SUBJECT: **RESPONSES TO MADISON HEIGHTS NEIGHBORHOOD ASSOCIATION CORRESPONDENCE- 253 S. Los Robles Avenue**

RE: PRISM Engineering's "Traffic Engineering Review" of 253 South Los Robles Project and Related Traffic Issues

253 SOUTH LOS ROBLES PROJECT AND RELATED TRAFFIC ISSUES

Figure 3: 2007 Fatalities at Intersections by Traffic Control Device

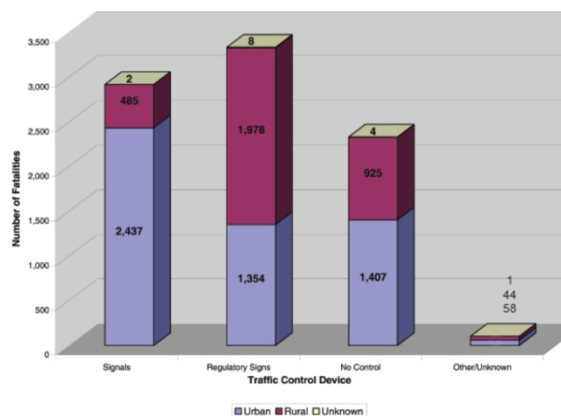
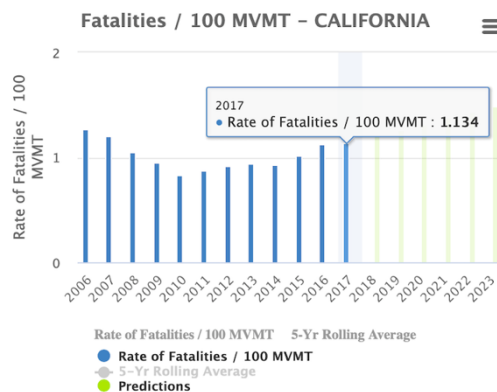
When the accident rate increases, as it did in California from 2010 to 2017, this is an indicator of a correlation between the number of cars on the road (congestion) and the increasing probability of a

serious or fatal accident. California roads are becoming increasingly congested, and the statewide fatality accident **rate** is going up, indicating that increased congestion correlates with increased probability of fatality, especially at a signalized intersection.

Citywide, total collision numbers are on a five-year downward trend. In addition, the total number of injury and fatal collisions are also on a five-year downward trend.

The downward trend in total number of reported collisions is also seen on the roadway segment of Los Robles Avenue between Cordova Street and California Boulevard (including collisions at the intersections of Los Robles Avenue/Cordova Street, Los Robles Avenue/Del Mar Boulevard, and Los Robles Avenue/California Blvd). The total number of reported collisions per year for Los Robles Avenue between Cordova Street and California Boulevard (inclusive of intersection collisions) is presented in the following table:

Year	Total Reported Collisions
2015	14
2016	8
2017	9
2018	8
2019	5

Use of the Traffic Model to Determine Traffic Impacts at Intersections is Incorrect

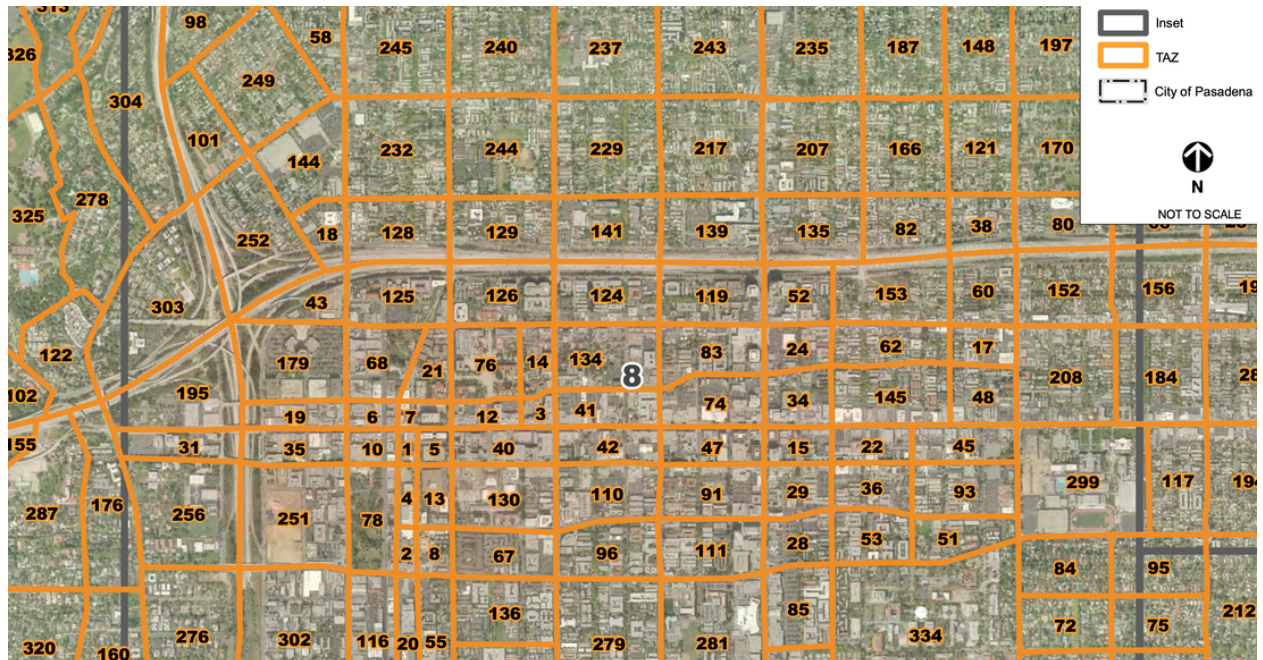
It is generally not appropriate to utilize a travel demand model tool to determine intersection turning movements, or to determine trip distribution assignments for a project, if the model is only accurate to macro level detail of roadway segments, not intersection turns. The City's traffic model has NOT been

This is not anywhere near precise or accurate enough to utilize model-generated turning movements at an intersections, or project trip distribution assignments for the very small 253 S. Los Robles project that is contained within a very small part of TAZ 67. The project is literally only 5% of the TAZ 67 total land uses, trip assignment is 95% influenced by the other land uses in the TAZ, and S. Euclid Ave even splits TAZ 67, so that the project could even potentially be assigned in the model directly to Marengo, let alone Cordova or Del Mar, which would not be correct.

Staff used professional judgment to manually assign/distribute project trips for the LOS and street segment analyses rather than the model suggested by the comment.

Staff uses a parcel-based calibrated Transportation Forecasting Model refined and built on SCAG's regional model. City's model is used in-house and is not shared with private consultants without authorization. The TDF model is calibrated to base-year to accurately replicate the actual traffic counts on major roads within certain margin of error established in 2010 California Regional Transportation Plan Guidelines.

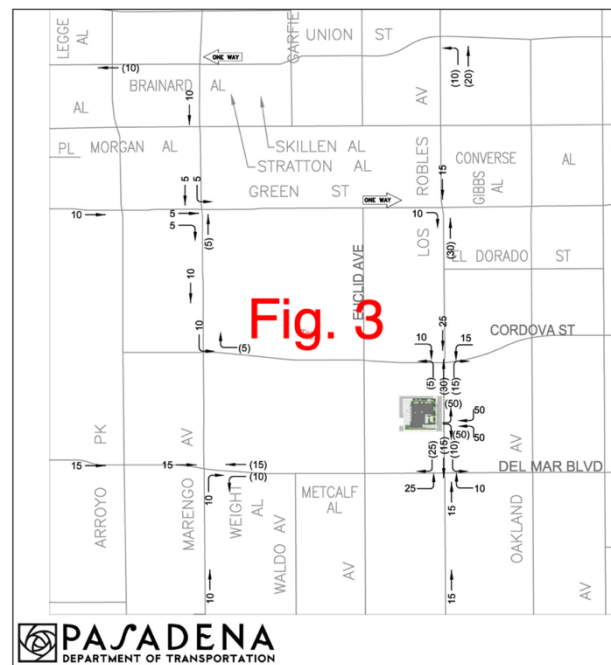
18. There are now long lines of congested traffic going northbound on S. Los Robles past the project site in the morning.
19. It is not reasonable that the project traffic could turn left in the peak hour as shown in the City's traffic study since there will not be a gap in the stop and go traffic. The project traffic is much more likely to turn right to go south out S. Los Robles and find another way to various destinations.

The traffic study showed a project traffic assignment as follows in the clip from Figure 3 of the report (below). Anecdotal information from residents who drive S. Los Robles on a regular basis indicates that there are currently long lines of traffic that back up on S. Los Robles in front of the proposed project site, and that the assumptions shown in Figure 3 could not happen, as there will not be a gap in traffic for project traffic to get out in the morning.

50% of the project traffic was assumed in the DOT study to make a left turn out of the project, presumably because the travel demand model showed this.

A closer look at the figure shows project traffic patterns that raises questions... such as 50% of the project turning left out to go north on S. Los Robles in the morning when there are long lines of northbound traffic already on the road that would prevent this from being reasonable/possible (no sufficient gaps in traffic).

Should northbound queuing along this section of Los Robles Avenue be a concern for motorists exiting the proposed driveway for 253 S. Los Robles Avenue, traffic signal timing can be modified at the intersections of Los Robles Ave/Cordova Street and Los Robles Ave/Del Mar Blvd to help create gaps in northbound traffic.

Staff concurs that although making left turns to travel north on Los Robles Avenue might be challenging for a brief and select short time periods in a day, but limiting the driveway operations for the balance of the day is not advised. Furthermore, restricting the driveway egress to southbound right-turn-only could potentially add more traffic to Los Robles Avenue segment south of Del Mar Boulevard.
